REMEDIATION SYSTEM EVALUATION

ELISKIM FACILITY
ANDERSON COUNTY, SOUTH CAROLINA

Report of the Remediation System Evaluation,
Site Visit Conducted at the Eliskim Facility, Anderson County, South Carolina
April 29, 2003

EPA 542-F-04-024
June 2004
www.epa.gov/tio
clu-in.org/optimization

FIGURE 1-1. THE ELISKIM PROPERTY, DOWNGRADIENT AREA, AND MONITORING WELL LOCATIONS INDICATING TCE CONCENTRATIONS FROM THE 2002 SAMPLING EVENT.

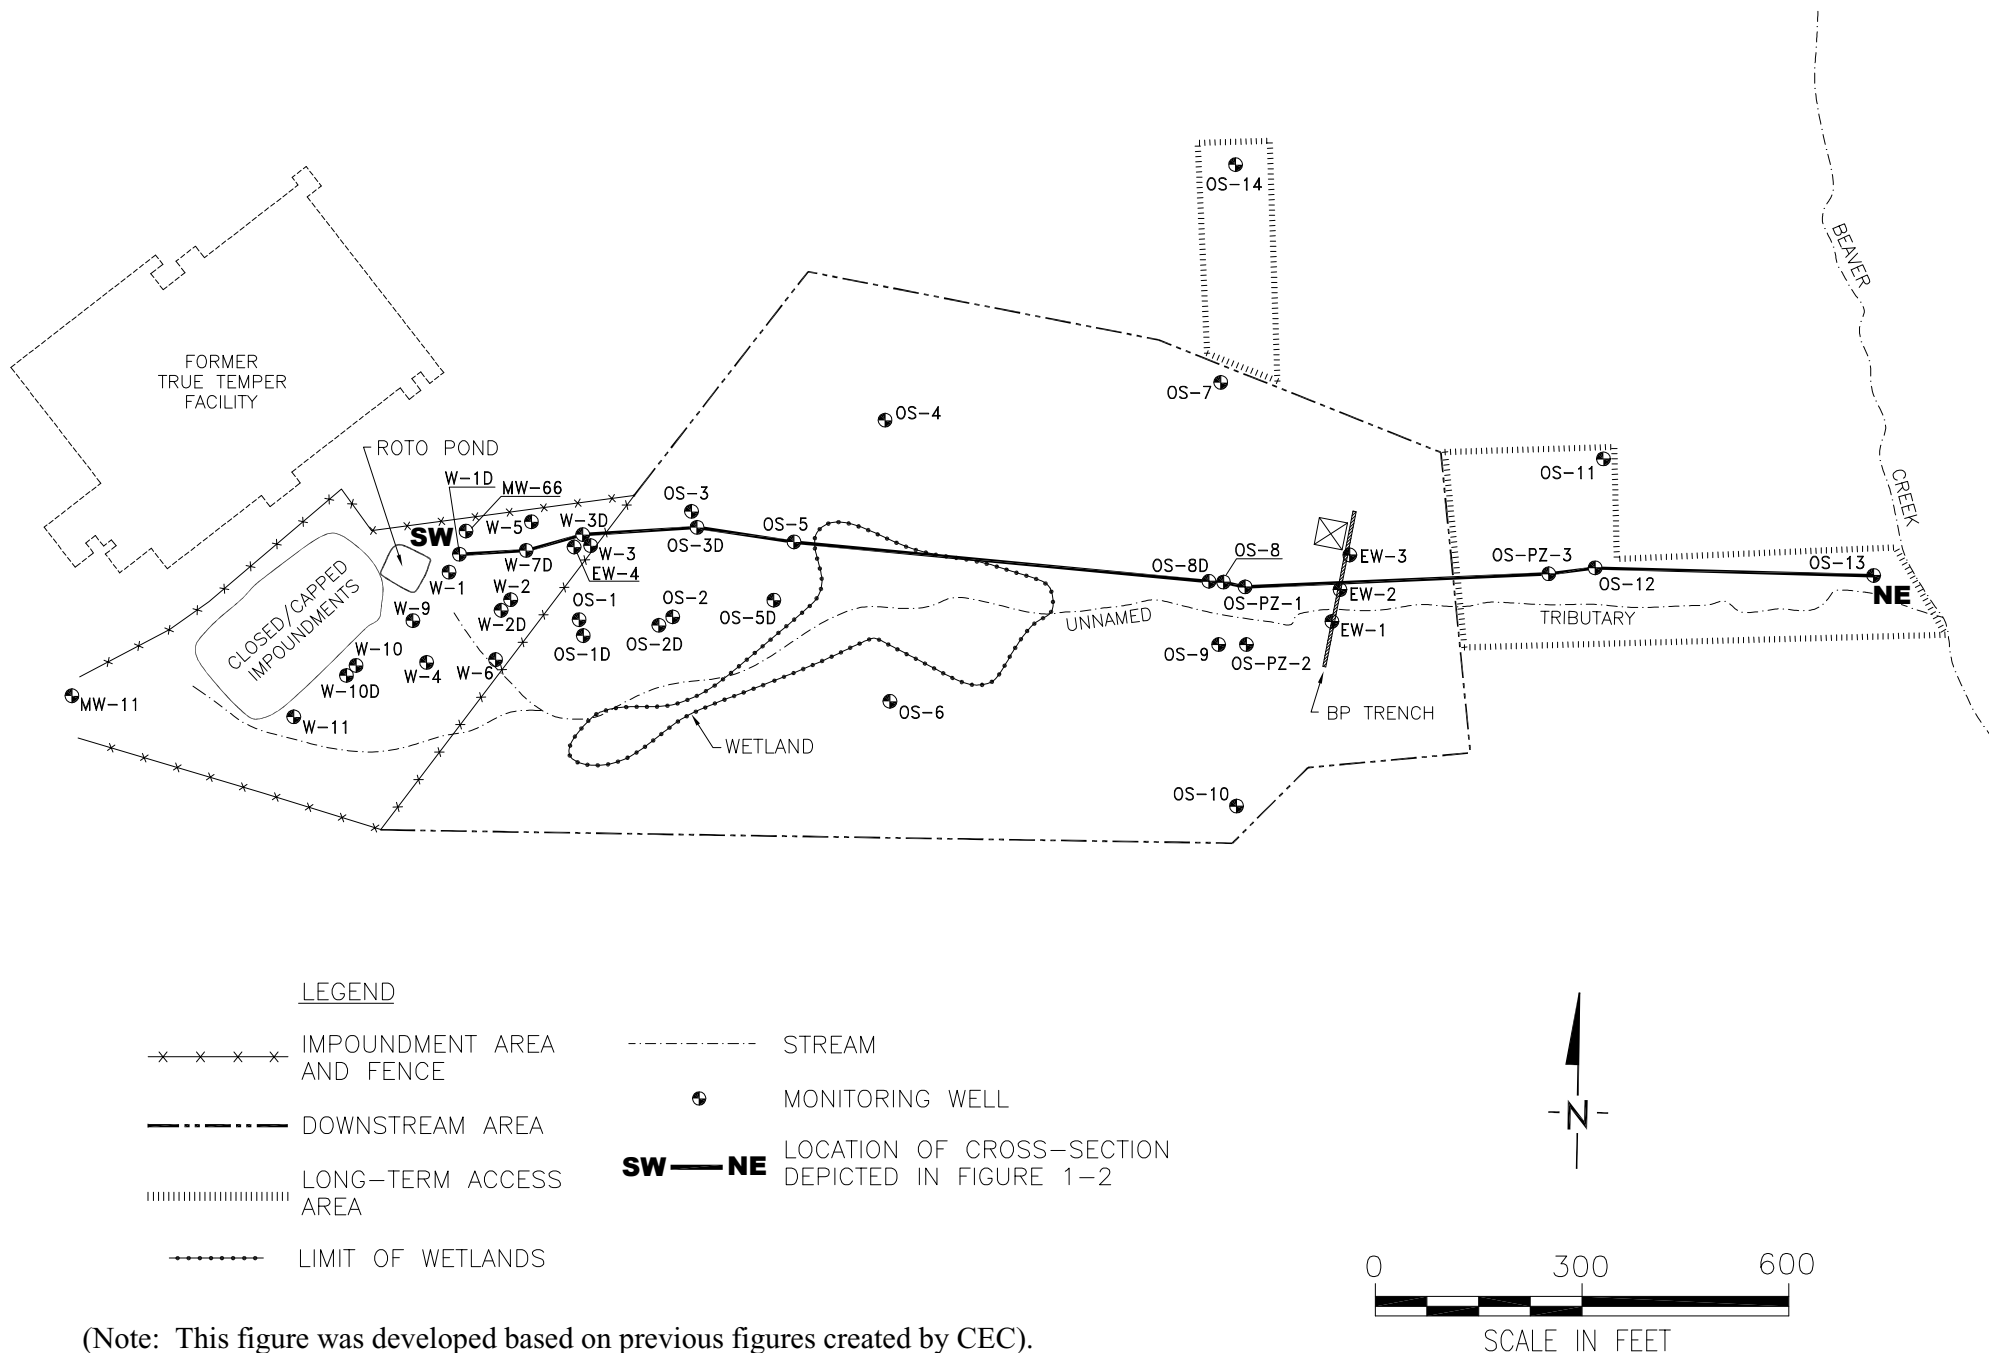
The Eliskim site is a closed hazardous waste management facility located approximately one mile south of Anderson, South Carolina. Key land parcels are illustrated on Figure 1-1. The original facility (the “Impoundment Area”) consisted of approximately five acres of property with ponds and lagoons used for hazardous waste management associated with a plant originally owned by True Temper that was located on an adjoining parcel. The plant was sold to Emhart Corporation in 1985, and is currently operating as a truck depot. An additional 20 acres east of the Impoundment Area (the “Downstream Area”) was purchased as part of the ground water remediation. A ground water collection trench and a treatment plant are located on this 20-acre parcel. The property north, east, and south of the Downstream Area is owned by Mr. Joseph Nehme (the “Nehme Property”), and that property contains several monitoring wells that are monitored and are accessible under access agreements.

As illustrated on Figure 1-1, two drainage ditches channel runoff from the former True Temper plant property and the capped area to form the unnamed tributary to Beaver Creek. Beaver Creek is located approximately 2,000 feet northeast of the original 5-acre facility.

The site is located in the Piedmont physiographic province. Bedrock beneath the site is a biotite gneiss which is overlain by overburden (saprolite which grades from weathered bedrock to silty clay and clayey silt). The contact between competent bedrock and overburden is not well defined. Competent bedrock has been observed onsite at depths ranging from 10 to 51 feet, and at depths up to 88 feet beneath areas along the unnamed tributary. A geologic cross-section is shown in Figure 1-2, and the location of that cross-section is indicated on Figure 1-1.

Vertical delineation of TCE should be considered for three areas:

Delineation in the source area would serve two purposes. First, it would help determine if contamination has the potential to migrate from the source area through the bedrock formation at depths that might not be sampled by the current program. There are deep wells in the source area that penetrate the bedrock. They are generally all installed to the same elevation, approximately 745 feet above mean sea level. The TCE concentrations in some of these deep wells were as high as 1,200 ug/L in 2002 (W-7D). Second, it would help in evaluating or planning source area remediation.
